STP 2009 (653) ES, STP ()
Categorical Exclusion
Bexar County
CSJs: 0253-04-139 & 0253-04-141

US 281 @ Loop 1604 Interchange

Re: U.S. 281 North at Loop 1604 Interchange Project – CSJ 253-04-139 and CSJ 253-04-141

Subject: Notice of Design Modification
CSJ: 0253-04-139, 141
Proposed Improvements to US 281 North/Loop 1604 Interchange
San Antonio, Bexar County, Texas

Figure 3A:
Typical Sections -
Categorical Exclusion

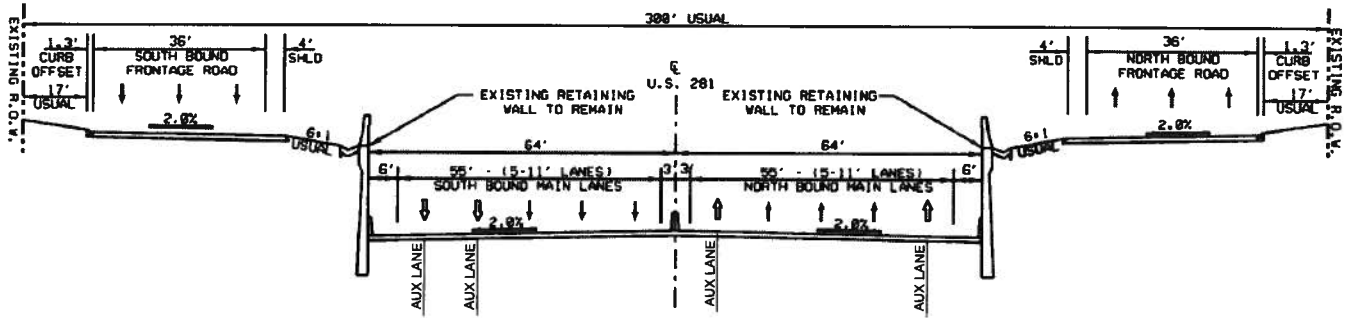
schematic identifies that additional auxiliary lanes will be added on US 281 as shown on Figure 3A and 3B.

The Re-Striping/Shoulder Reduction design modification provides the additional auxiliary lanes configuration on US 281 by re-striping the existing US 281 North northbound and southbound mainlanes from Bitters Road to Loop 1604. In order to accommodate the proposed number of lanes within the existing edges of pavement, the design modification includes a design exception request that would allow reduced shoulder widths, supplementing the existing approved design exception for reduced shoulder widths dated November 1, 2006. For US 281 northbound and southbound mainlanes, the inside shoulder width will be 2' and outside shoulder width will vary between 5' and 16' throughout the project limits. The areas of increased shoulder width will allow sufficient outside shoulder to provide for emergency use. With the proposed additional auxiliary lanes and approval of this reduced shoulder width design exception, re-striping the US 281 mainlanes will give the motorist a consistent alignment through this corridor with the use of a 2' inside shoulder.

Figure 3B:
Typical Sections -
Categorical Exclusion

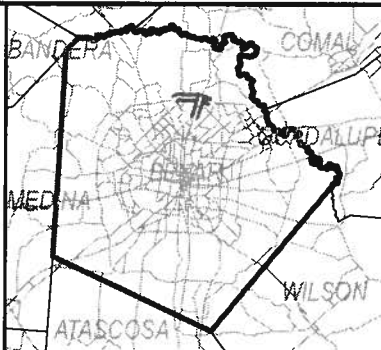
Additionally, it was noted that Figure 3B incorrectly designated auxiliary lanes as through lanes so we have enclosed the corrected Figure 3B for your files.
